July 9, 2013

ADDENDUM NO. #2
Jefferson County Public Works
Vehicle Maintenance Facility

AD2-A2

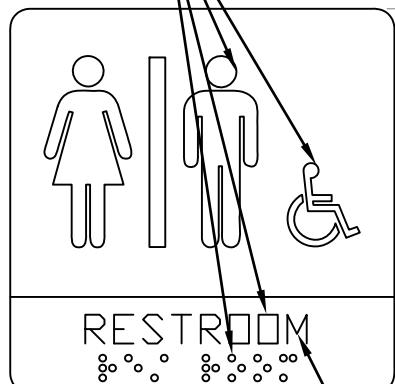
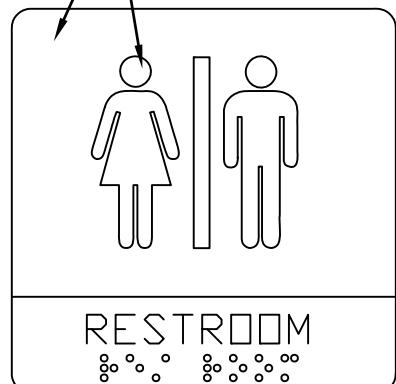
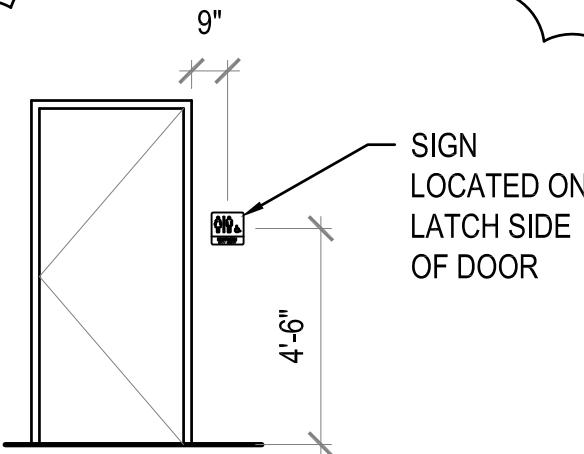
1. Panel signs are to be at restrooms 101 and 102; see AD2-A1 and AD2-A2 for additional information.
2. All new conduit (electrical and fire protection related) in Maintenance Bays 111 and Heavy Parts Cage 110 may be surface mounted, and are not required to be recessed behind existing drywall.

NOTE: SIGN CONFIGURATION, LETTERING, CHARACTERS
AND BRAILLE TO COMPLY WITH 2010 ADA REQUIREMENTS
